HOPE CREEK GENERATING STATION  
DOCKET NO. 50-354  
FSAR COMMITMENT STATUS THROUGH AUGUST 1984

ATTACHMENT I  
HOPE CREEK GENERATING STATION  
FSAR COMMITMENT STATUS THROUGH AUGUST 1984

QUESTION 220.21 (SECTION 3.7.2)

FIGURE 220.21-34  
 RESPONSE SPECTRA COMPARISON,  
 AUXILIARY BUILDING AT ELEV. 54' -0",  
 VERTICAL, OBE, 2% DAMPING

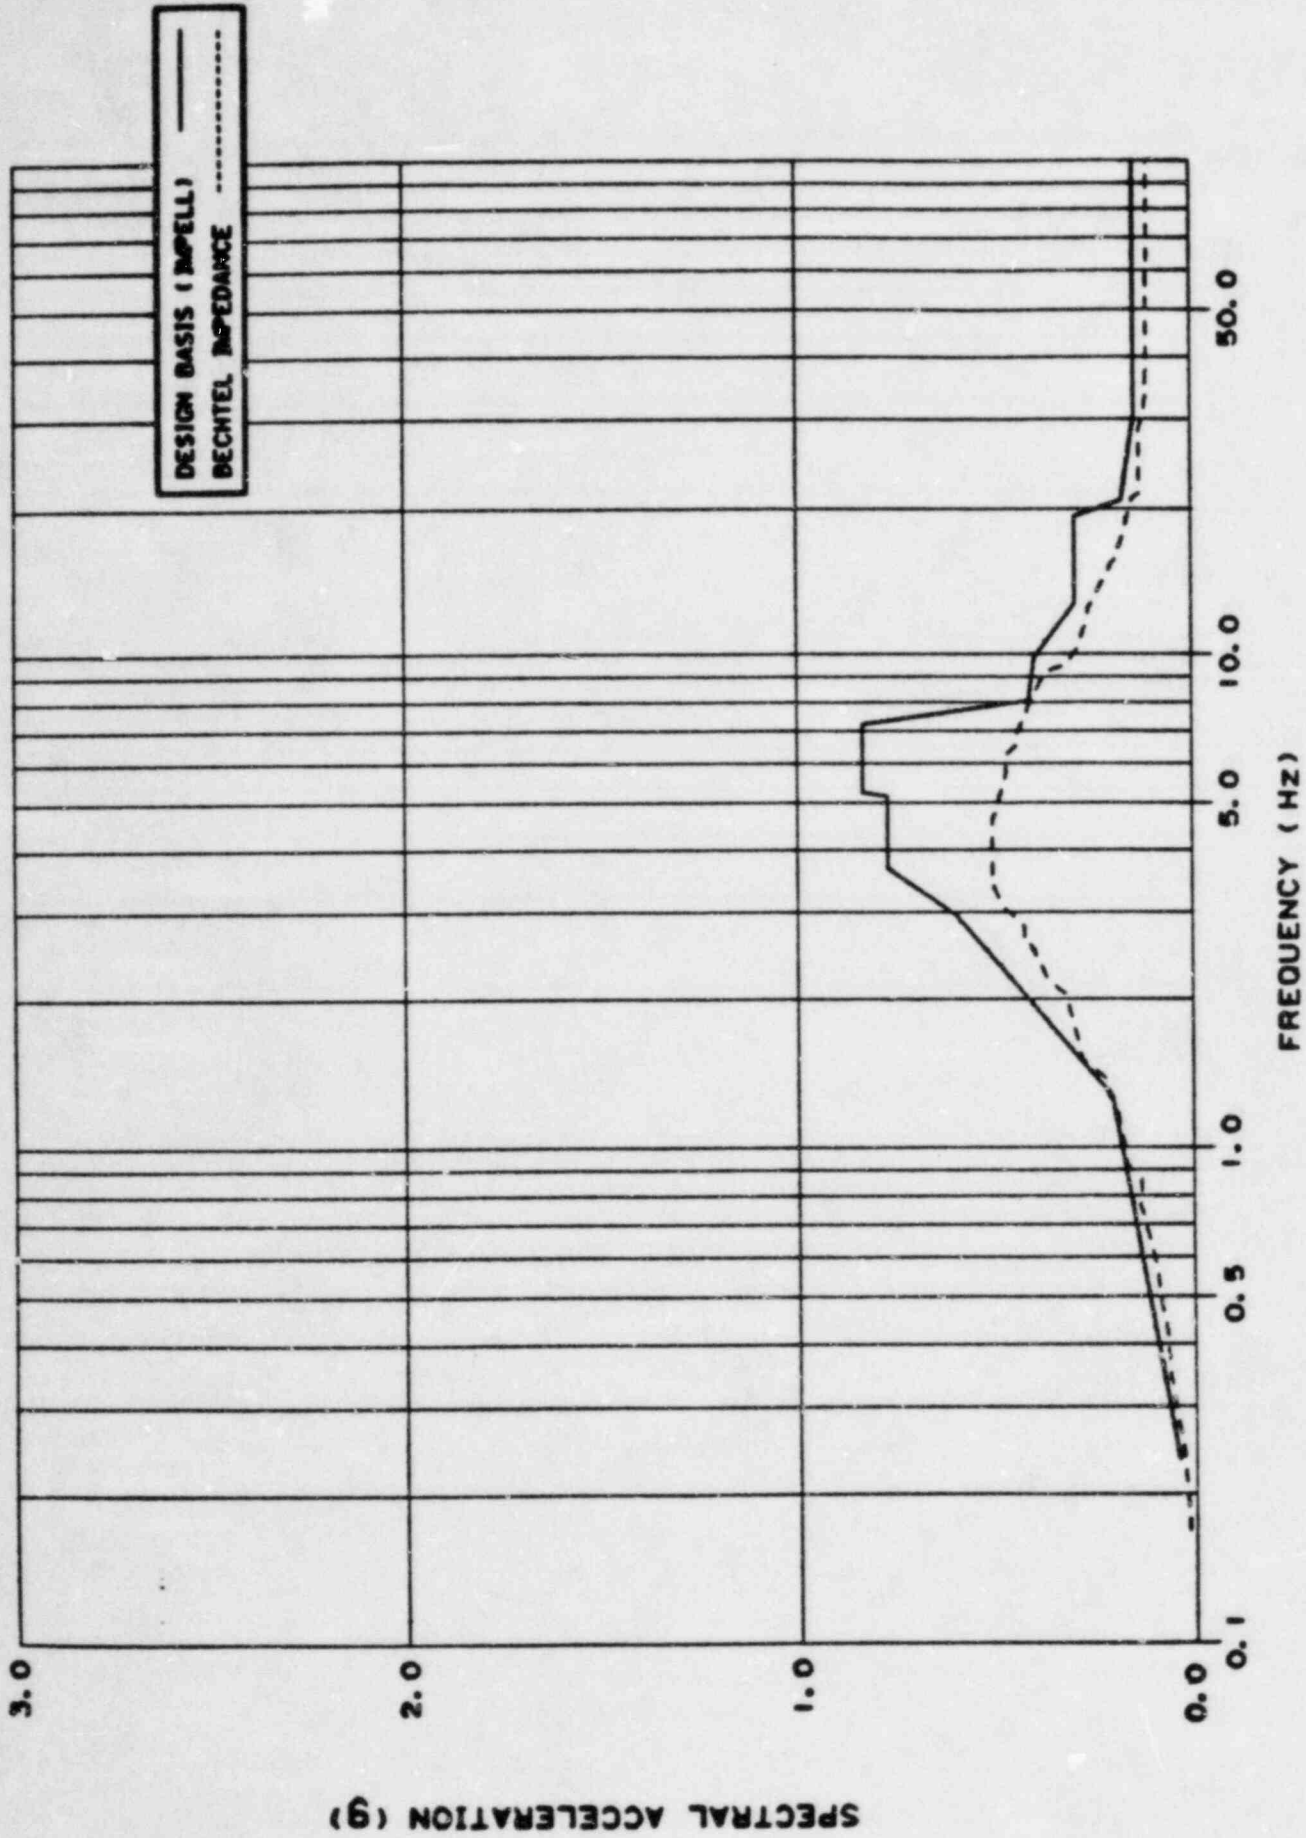
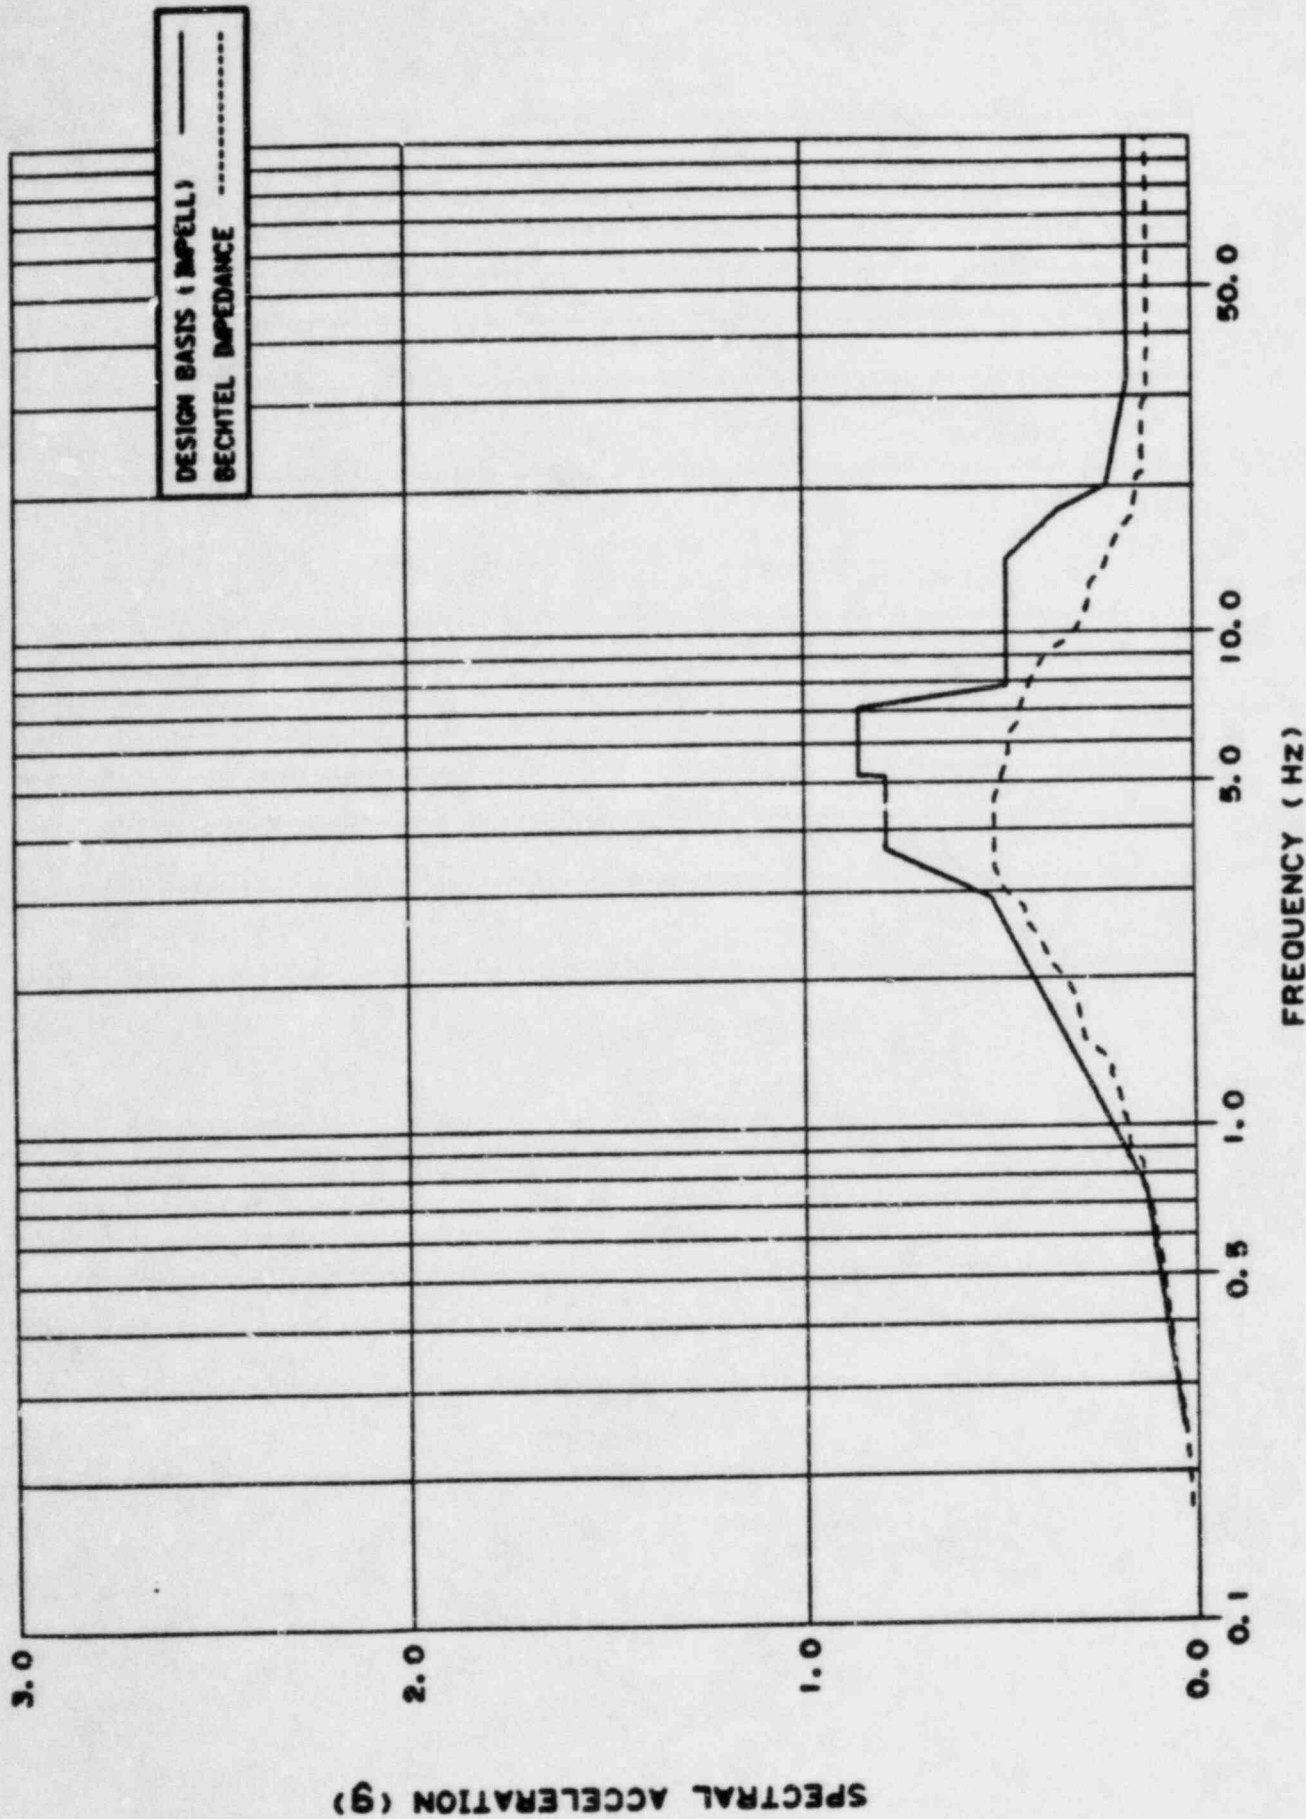
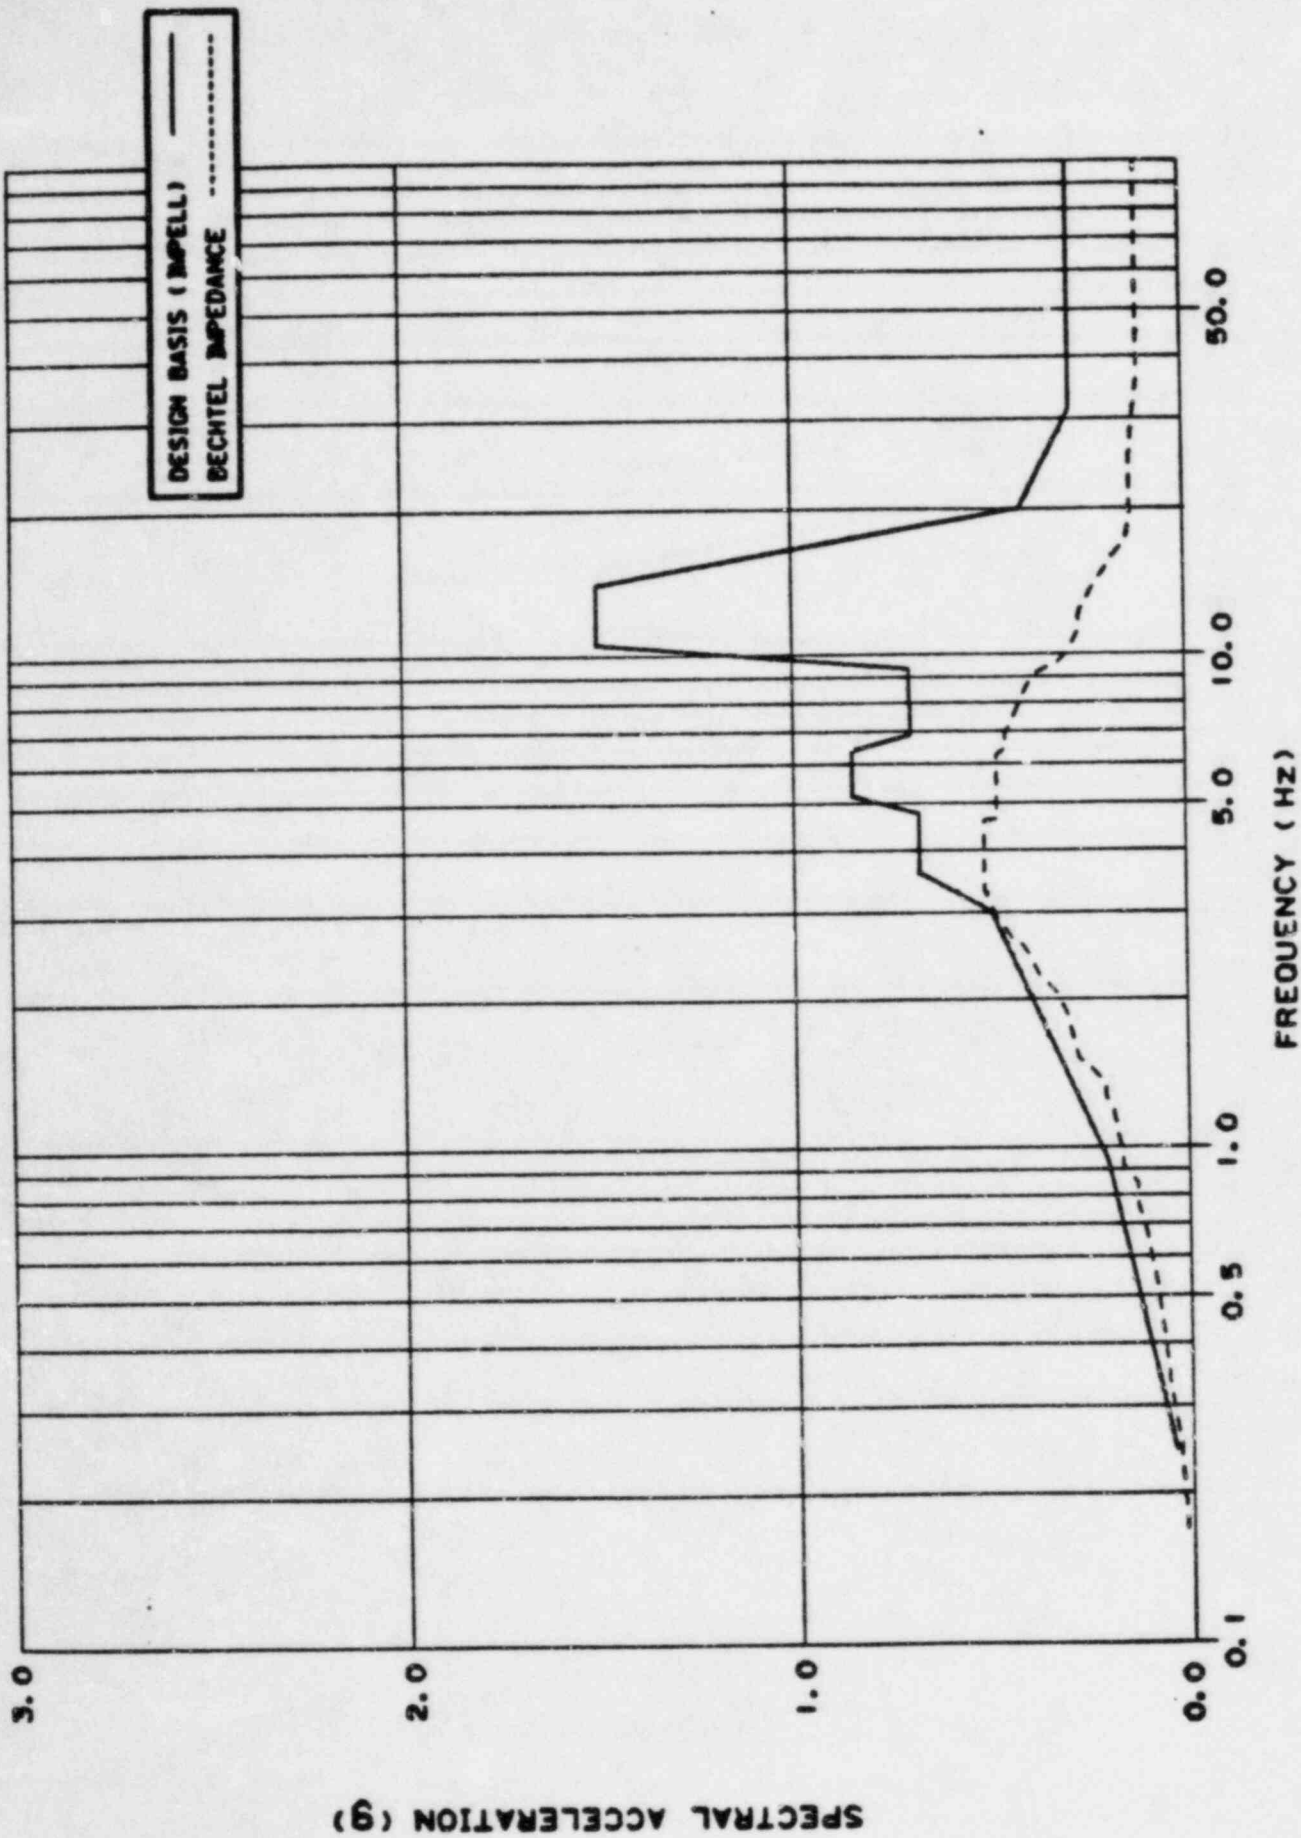
The Hope Creek soil-structure interaction analysis is performed by applying a specified earthquake input motion at the base of the finite-element model. The base level input motion is generated through a deconvolution analysis. The applicable SRP criteria for soil-structure interaction analysis require that both the half-space and finite-element approaches should be considered. (For details refer to SRP 3.7.2-11.4). Public Service should perform necessary analyses to demonstrate conformance to the criteria.

Figures 220.21-1 through 220.21-54 show a comparison of the 2 percent damping response spectra obtained from the design basis finite element and the impedance analyses for the reactor building, auxiliary building and the service water intake structure (SWIS).

¶ For the reactor and auxiliary buildings, the peak spectral accelerations obtained from the impedance analysis are generally lower than those obtained from the design basis analysis. However, the impedance analysis response spectra are not completely enveloped by those obtained from the design basis analysis, especially in the frequency range from 1.0 to 3.5 Hz. Also, there are some local exceedances in the higher frequency range, as shown in Figures 220.21-1 through 220.21-36. ¶ For the SWIS (Figures 220.21-37 through 220.21-54), the impedance analysis response spectra are generally enveloped by those obtained from the design basis analysis at elevation 114.0 feet. For other elevations, the impedance analysis spectral accelerations exceed the design basis spectral accelerations in some frequency ranges. These ranges vary approximately between 1.5 and 10.0 Hz.

forces and moments obtained from the impedance analysis exceeded the design basis values at various locations within these buildings. The auxiliary building seismic shear forces and moments obtained from the impedance analysis are less than the design basis shears and moments.

Since the impedance analysis results are not completely enveloped by the design basis finite element analysis results, sampling studies are conducted to confirm the adequacy of the plant design. These sampling studies include an evaluation of the following items:

In all cases, the items reviewed during these sampling studies can accommodate the loads resulting from the impedance analysis. Therefore, the impedance analysis results have no impact on the plant design.
